Reference: Project SSC Cortlandville II LLC – Installation of a 5.0 MWAC solar power facility south of Blue Creek Road.

RE: Project No. 2020.260.001 Application for a 5 MW Solar Array and Subdivision

Sheet: Planning Board
 Title: SITE PLAN
 Date: 2020.07.22
 Drawing No.: C-200

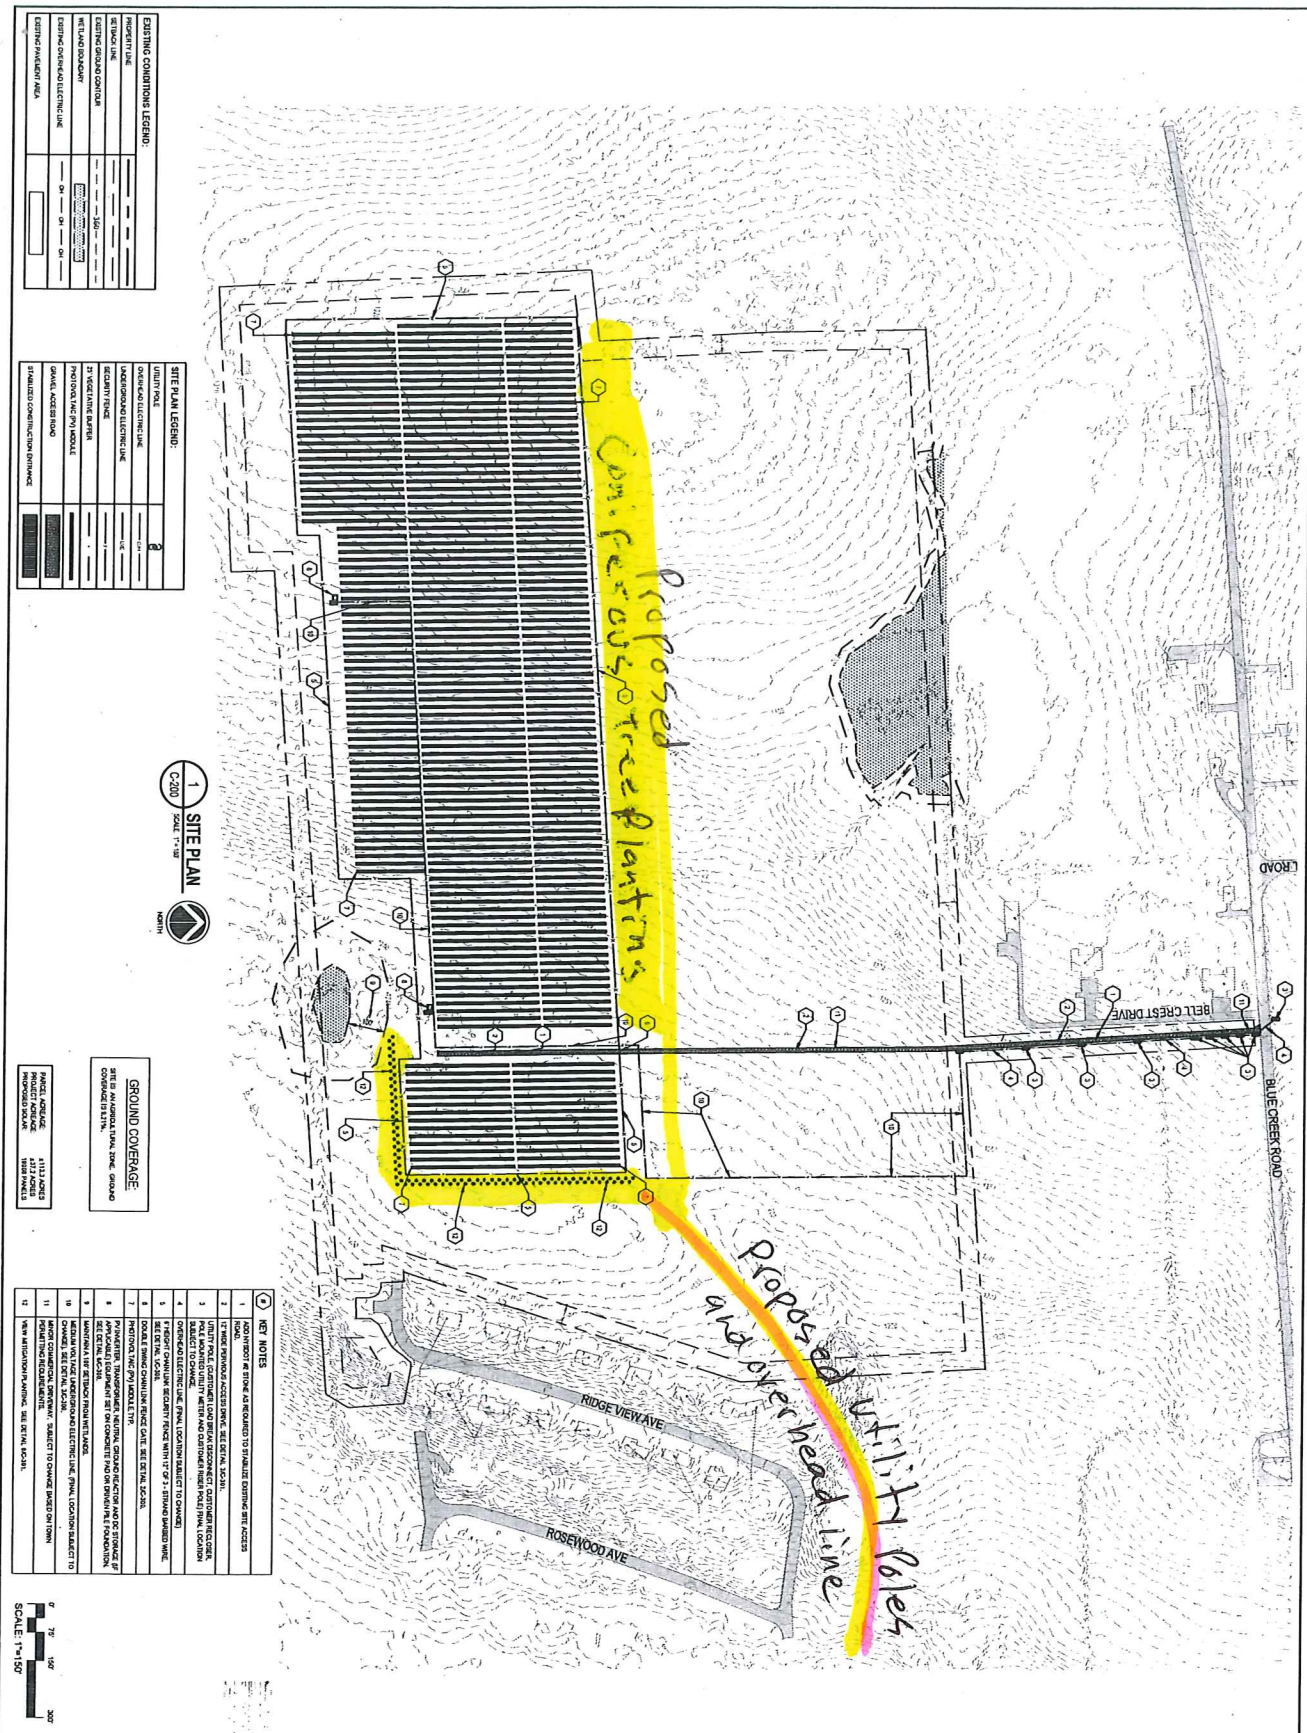
1. The access road will not remain permeable and should be considered impermeable for the analysis of stormwater runoff impacts. Foundations for

the panel racks and fences will also create a minor amount of impermeable surface.

2. The contour lines on Delta Engineering's plans are probably from LIDAR data and don't accurately represent the existing topography of the site. Most obvious is the absence of the north-south swale across the farm and of the new detention pond. Accurate topo data is needed for final design of this project."
